UNITED STATES PATENT AND TRADEMARK OFFICE

Office Action Summary	Application No. 10/661,177	Applicant(s) CRUSIUS ET AL.	
	Examiner Adi Amrany	Art Unit 2836

DETAILED ACTION

Fig. 1

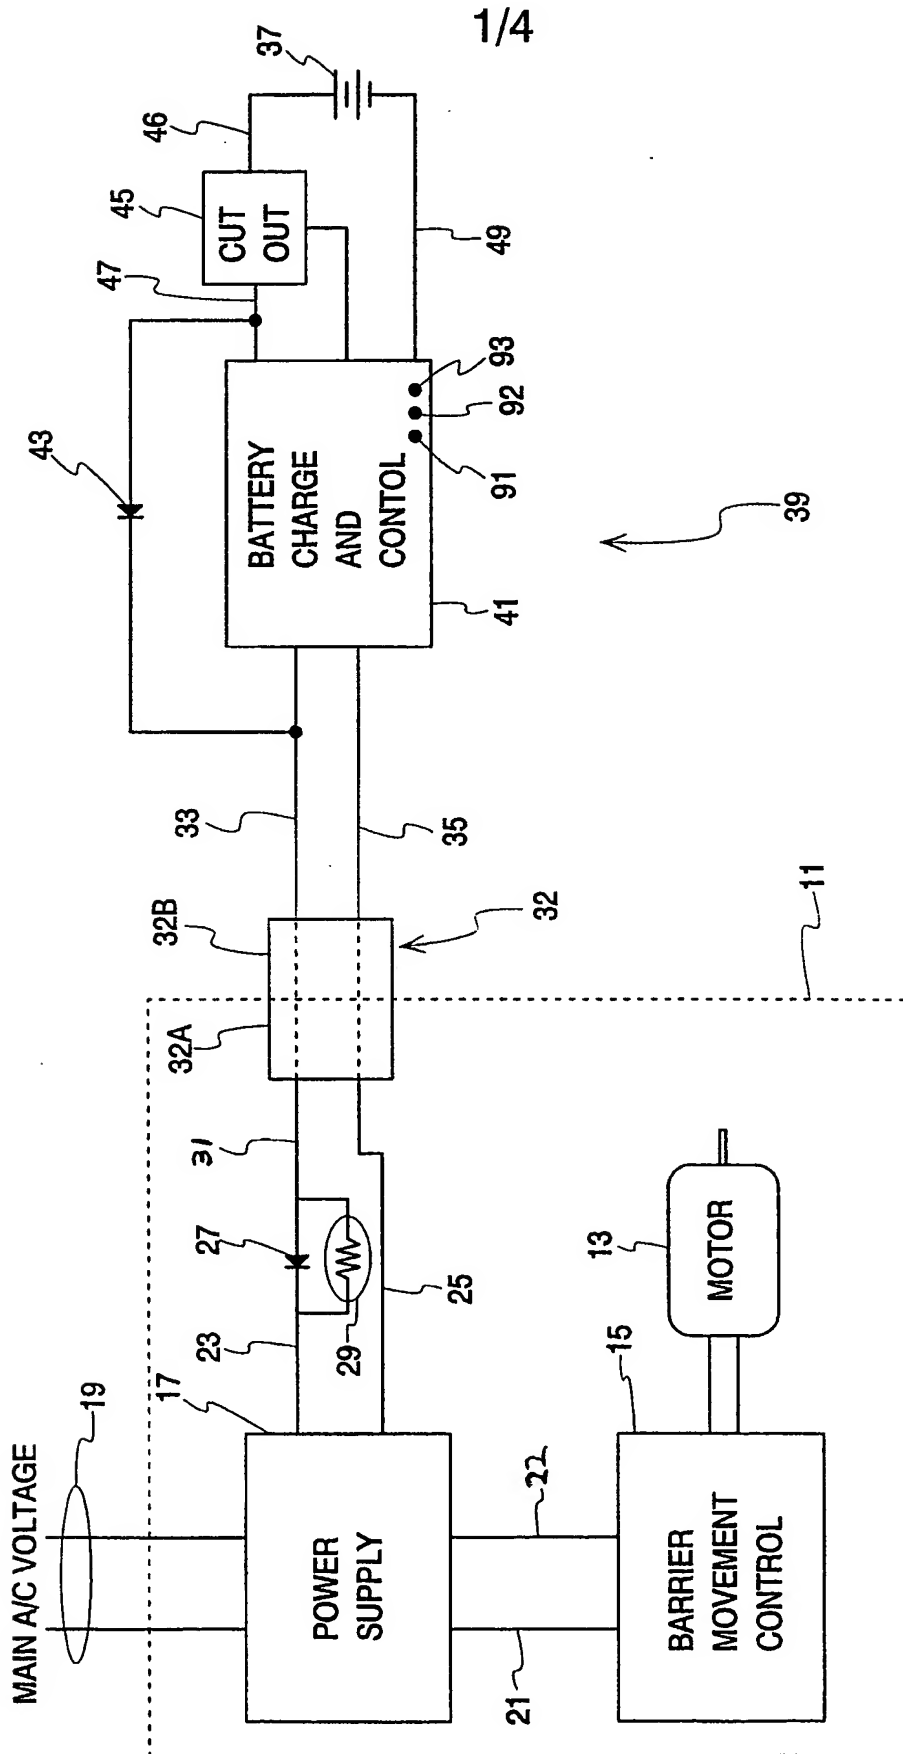
2. Replacement figure 1 was received on October 10, 2006. The drawings is accepted.
